CITY OF MERCER ISLAND

August 1, 2018

Re: Approval of a Reasonable Accommodation Request re:
Expanded driveway, walkways, and patio located at 6121 84th Ave SE Mercer Island, WA 98040; Parcel
ID: 192280-0340

Attachment B- Second Submittal Documents

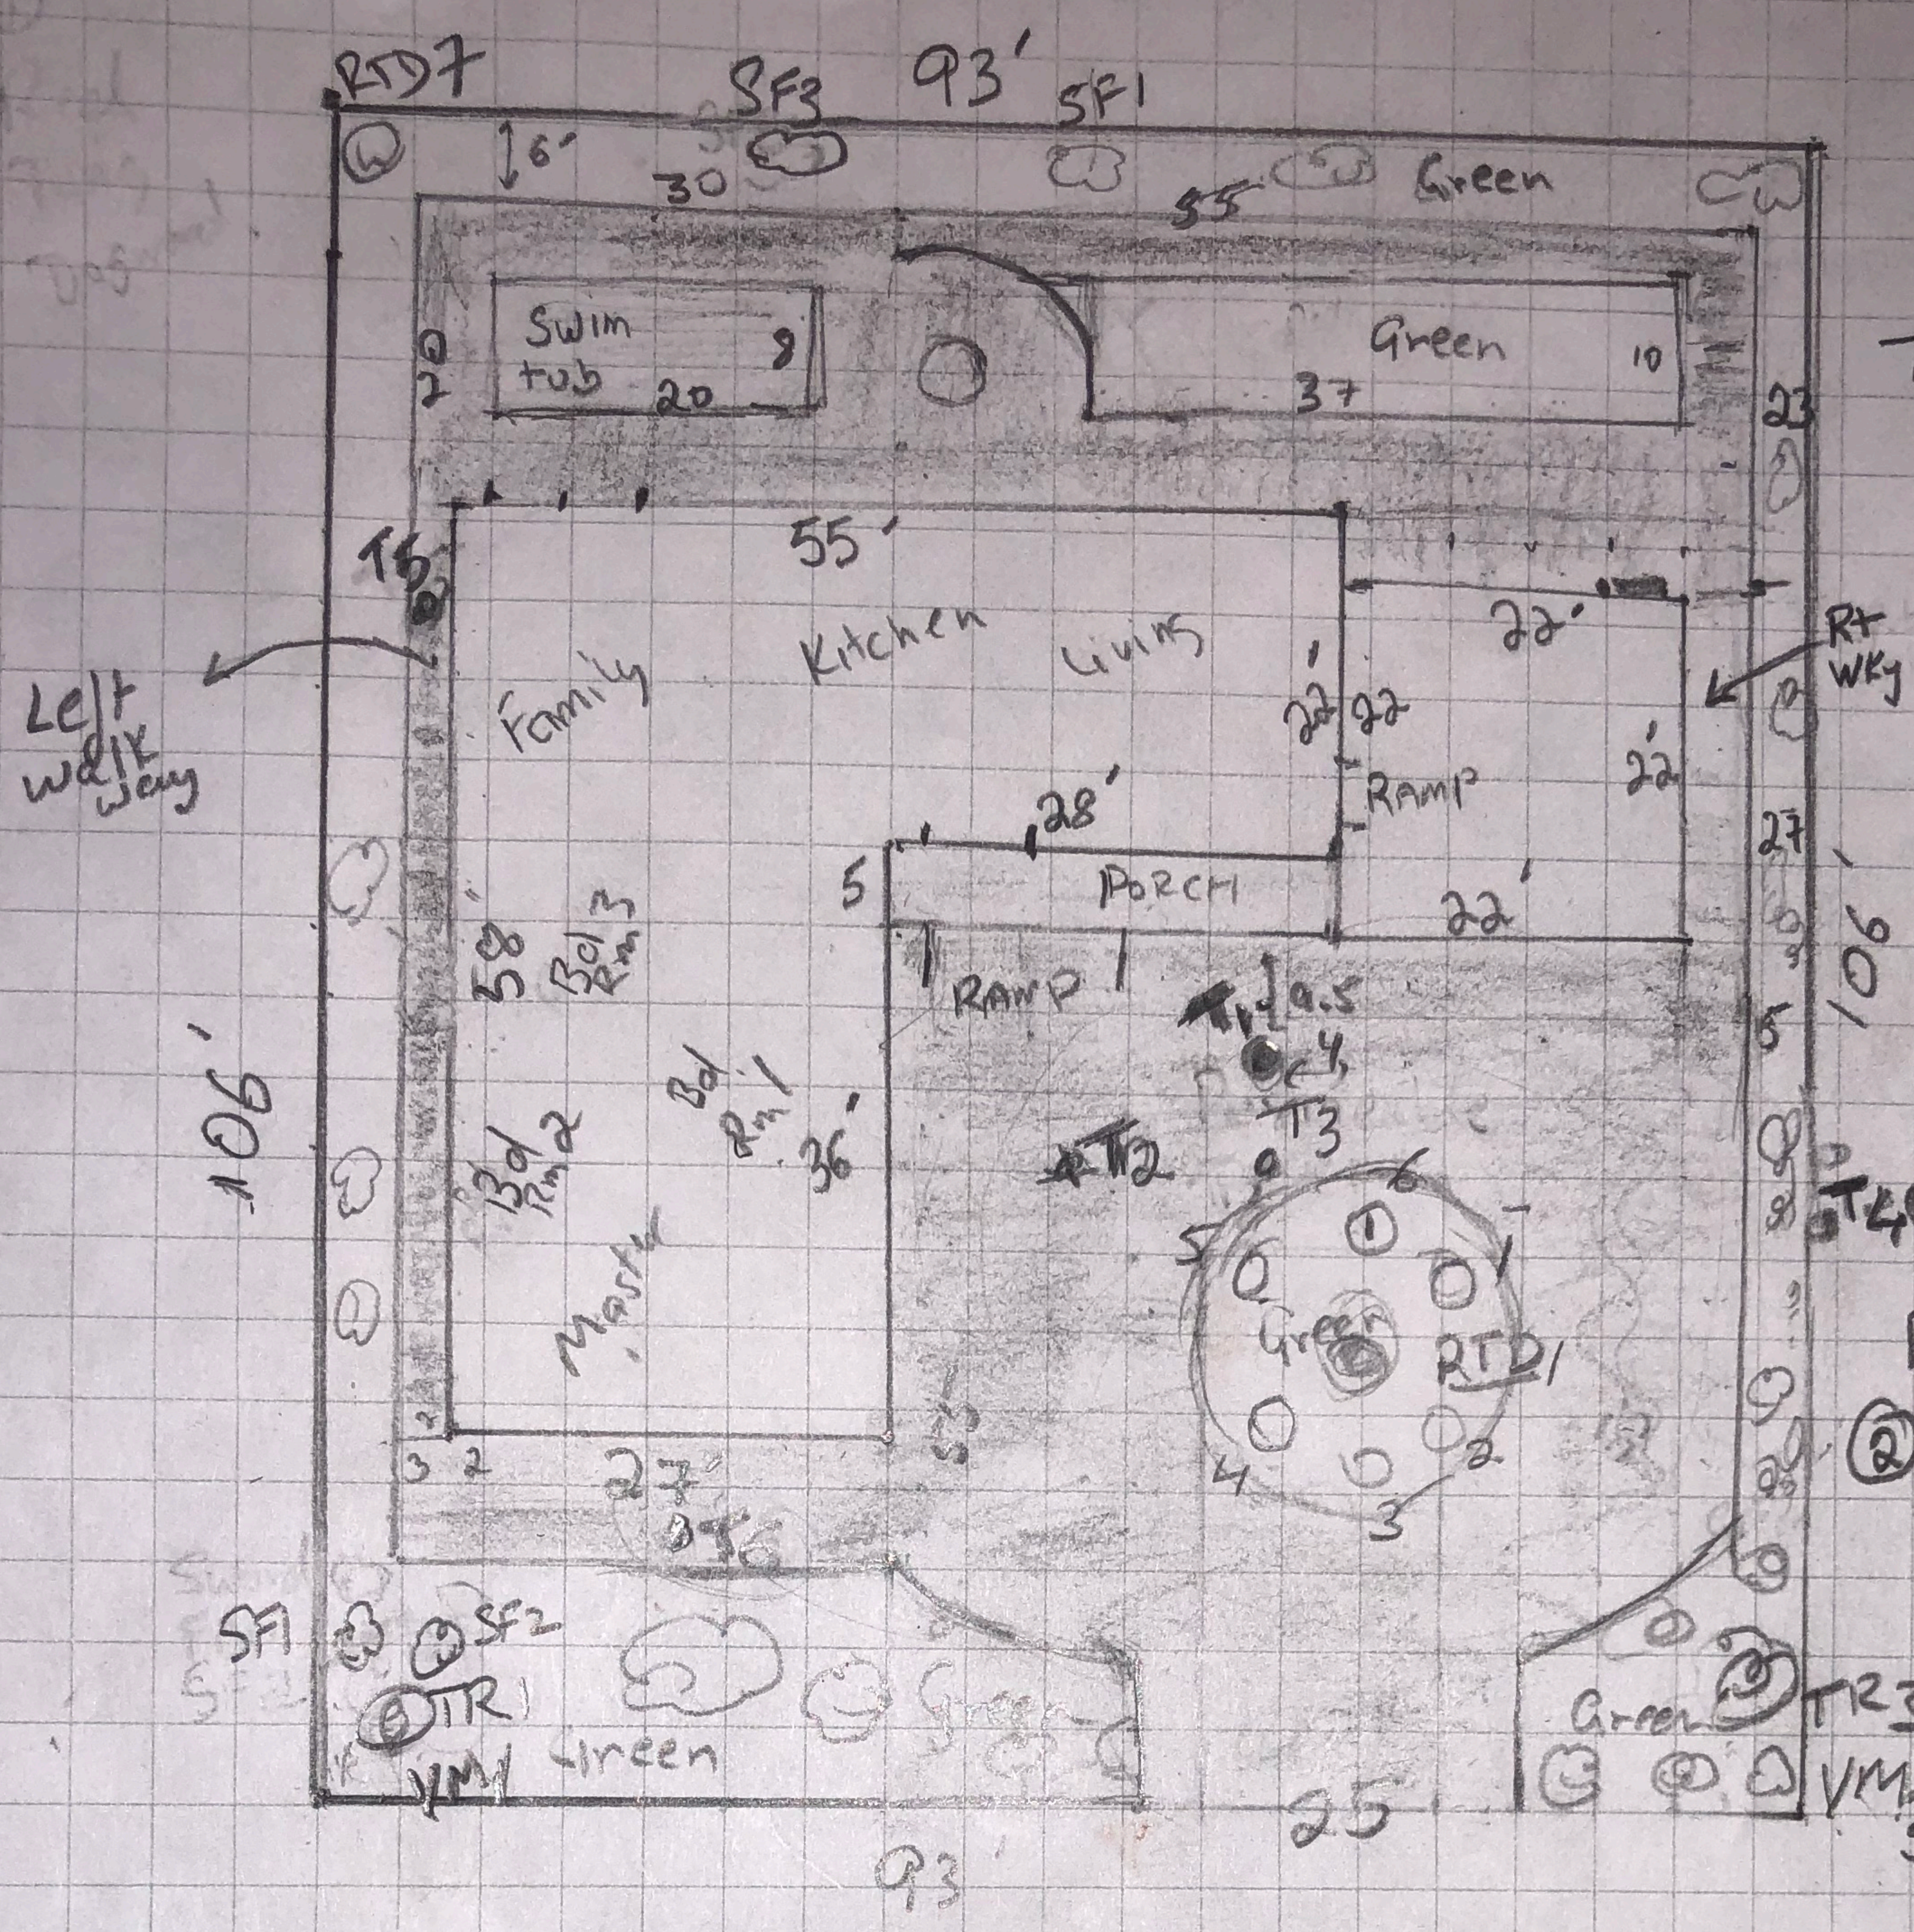
2. A landscaping plan is required, to mitigate for impacts resulting from the additional lot coverage and hardscape. Please provide additional landscaping information, that includes the following:

- a) A landscaping plan that specifies the proposed type of plants, species, location of plantings, and estimated quantity. Please note that native or adaptive species are preferred; and,

- b) A narrative how the plants provide a natural screening barrier.

Here is the updated plan. It is changed to Teardrop driveway.
Overall driveway is now reduced from 1950 sq ft to 1698 sq ft.
This reduces the over all total to 68% of hardscape which is 12% for special consideration.

We have consulted a local landscape design and we will be able to save one of the native Vine Maple tree (marked T2).
Overall we will have following native plants at the marked locations

Trees Removed
T1, T3, T5, T6

Tree Relocated
T2 → TR1 (VM)

Native tree added

TR2 - VM2
TR3 - VM3

Native Shrub Added

RTD 1, 2, 3, 4, 5, 6, 7
Real twig (7)
Dogwood

Sword Fern (3)
SF1, 2, 3

Special Consideration
= 6762 - 5323 = 1439 sq ft
= 6510 - 5323 = 1187 = 14+5%
= 12%

Driveway - 1 + 950 sq ft
 $(45 \times 55) + (15 \times 20) + (15 \times 55) \rightarrow 1698$ sq ft
 $(55 \times 35) + (375) - 602.8$
